SB-GA8-2009-60

Issue 2

Service Bulletin

Replacement of Exhaust Support Strap

Figure 1

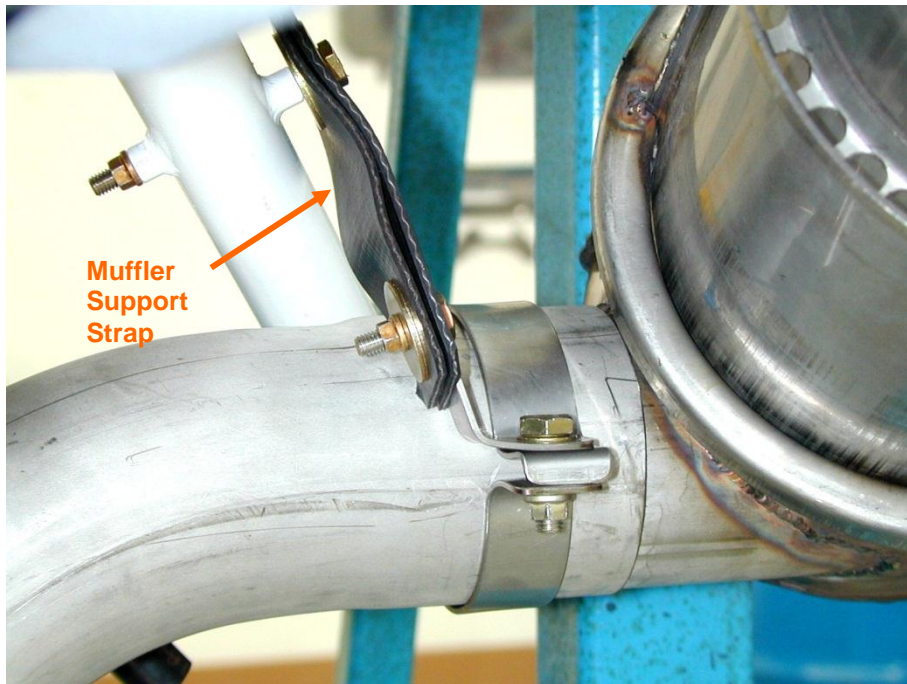
Service experience has shown that movement of the mufflers can result in fretting damage to the nose leg support braces, firewall shield or engine mount frame. The replacement exhaust support strap locates the muffler more rigidly but allows for adequate vibration dampening.

1. Remove muffler support Strap (GA8-710021-31) as shown in Figure 1.

2. Using the existing hardware, install new Muffler Support Strap (GA8-710021-131) as shown in Figure 2.
